UNITED STATES PATENT AND TRADEMARK OFFICE

APPLICATION NO.	FILING DATE	FIRST NAMED INVENTOR	ATTORNEY DOCKET NO.	CONFIRMATION NO.
09/695,840	10/26/2000	Shinsuke Henmi	Q61431	3264
7590 12/15/2006			EXAMINER	
Sughrue Mion Zinn Macpeak & Seas 2100 Pennsylvania Avenue NW Washington, DC 20037			MULLINS, BURTON S	
			ART UNIT	PAPER NUMBER
			2834

Office Action Summary**Application No.**

DETAILED ACTION

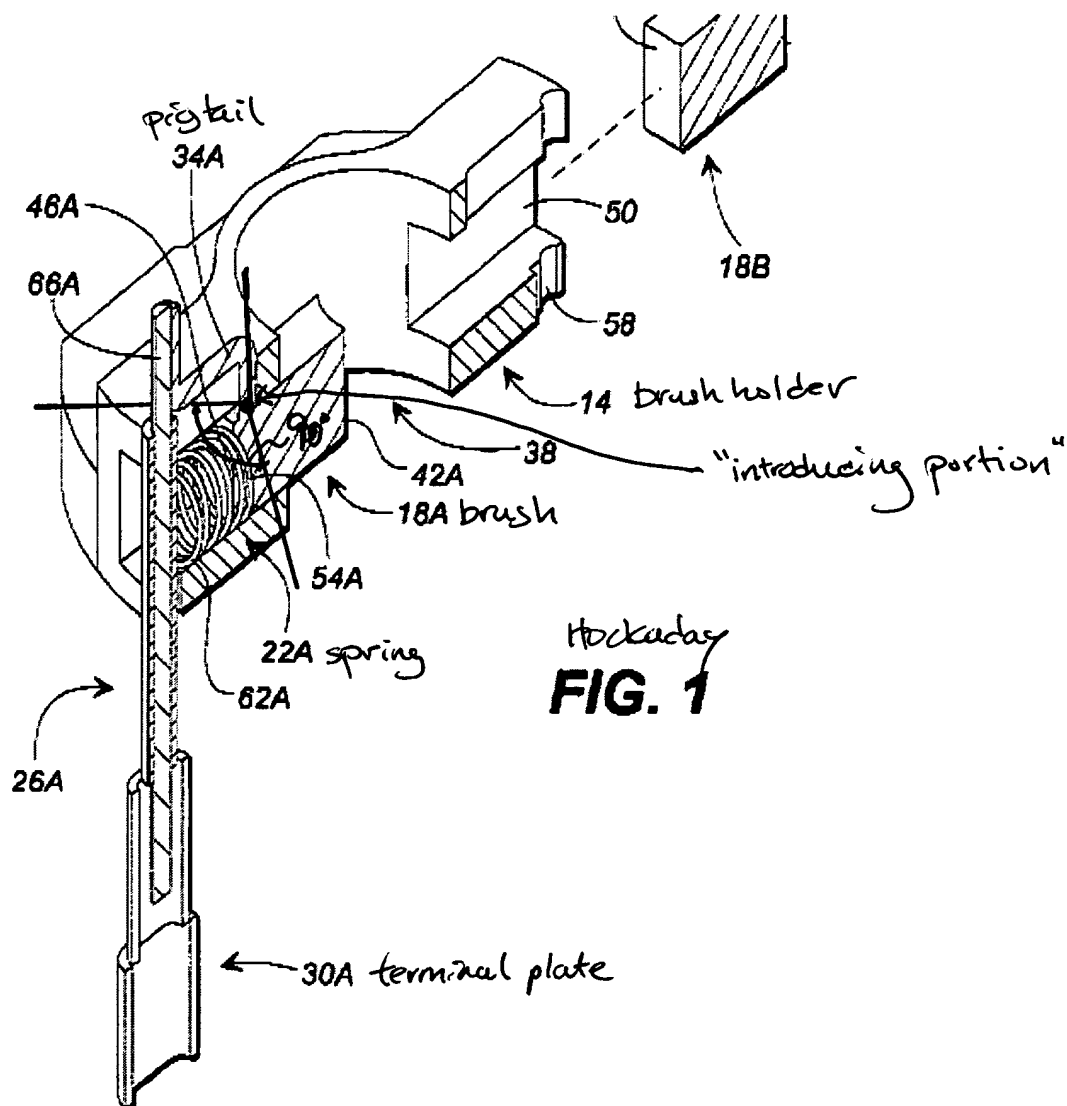
Hockaday teaches a brush holder and lead arrangement for a dynamo-electric machine comprising a brush holder (holder/card) 14 including a spring 22A and a brush 18A set in a brush holder base (slot) 50 (Fig.1). A pigtail 34A extends from an introducing portion in the brush 18A (i.e., pigtail 34A connects with brush 18A at a connection point, not numbered; Fig.1) in a radial direction of the brush holder (i.e., the pigtail 34A extends radially relative to the machine axis, as does the brush holder 14; Fig.1), and a terminal plate 30A and the pigtail 34A are connected in an area within 90 degrees from an introducing portion toward the radial direction of the brush holder (at portion 66A; see marked Fig.1 below).

Regarding claim 2, in Hockaday the terminal 30A and the pigtail 34A are connected in an area around a sliding axis of the brush “within the width of the brush” [sic] since the terminal/pigtail connection at portion 66A lies more or less radially of the brush 18A (Fig.1).

Regarding claims 3-4, in Hockaday, the pigtail is “introduced from the brush” [sic] in a direction toward a motor shaft (not shown, inherent) since the pigtail 34A is routed to the brush 18A along a generally radial path (Fig.1).

Regarding claims 5-7, in Hockaday a column comprising portion 66A extends from the terminal plate 30A to connect with the pigtail 34A (Fig.1).

Regarding claims 8-11, in Hockaday, the pigtail is “introduced from a backside of the brush” [sic] in the sense that the pigtail 34A is routed to the brush 18A along a generally radial path, from the direction of the backside of the brush, or that the pigtail connects to the brush at one end of the brush, i.e. a radial “backside” of the brush (Fig.1).
